Product Change Notification / LIAL-15QPNY176

CCB 4506 Initial Notice: Qualification of MMT as an additional assembly site for selected products available in 8L TDFN (2x3x0.8mm) package.

CCB 4506
Pre and Post Change Lead Frame Comparison
PCN # LIAL-15QPNY176

Lead frame comparison

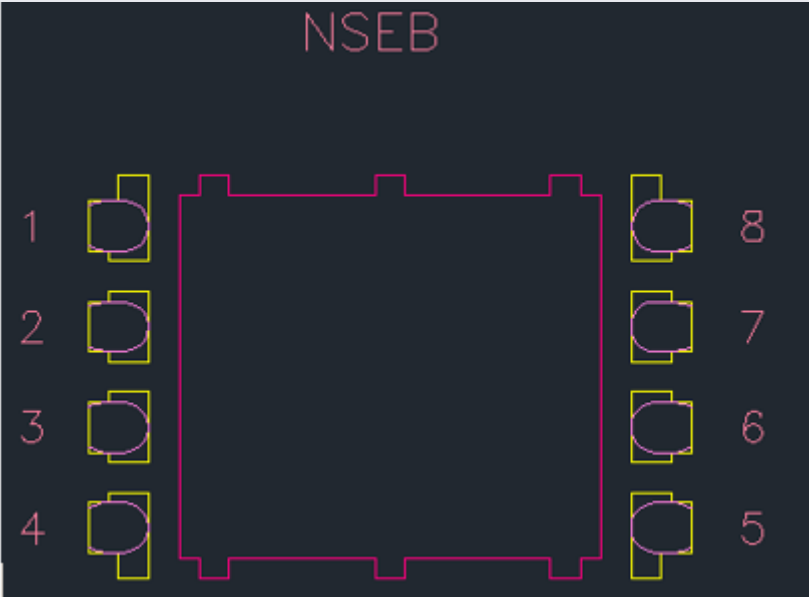
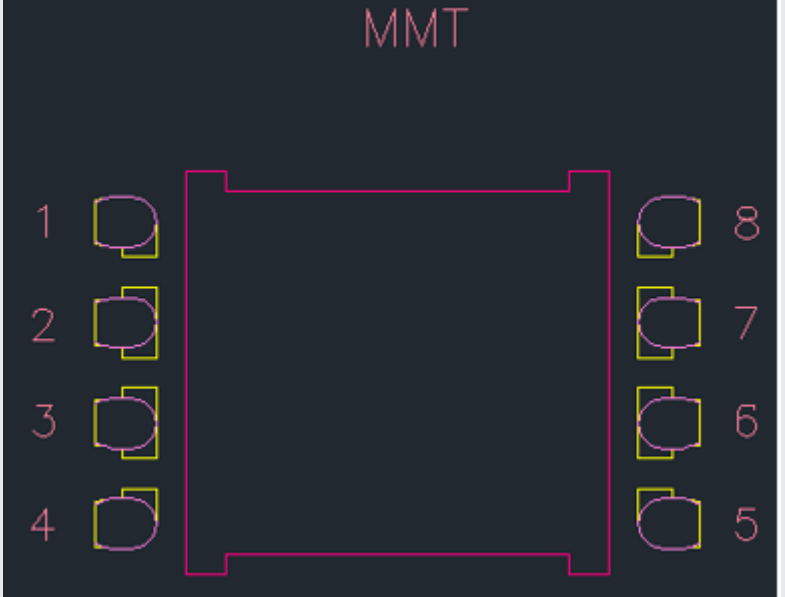
Pre change	Post Change				
NSEB	MMT				
<p data-bbox="267 472 1072 1063"></p> <table border="1" data-bbox="287 1082 1049 1159"><tr><td>Lead frame lead-lock</td><td>No</td></tr></table>	Lead frame lead-lock	No	<p data-bbox="1508 472 2288 1063"></p> <table border="1" data-bbox="1508 1082 2280 1159"><tr><td>Lead frame lead-lock</td><td>No</td></tr></table>	Lead frame lead-lock	No
Lead frame lead-lock	No				
Lead frame lead-lock	No
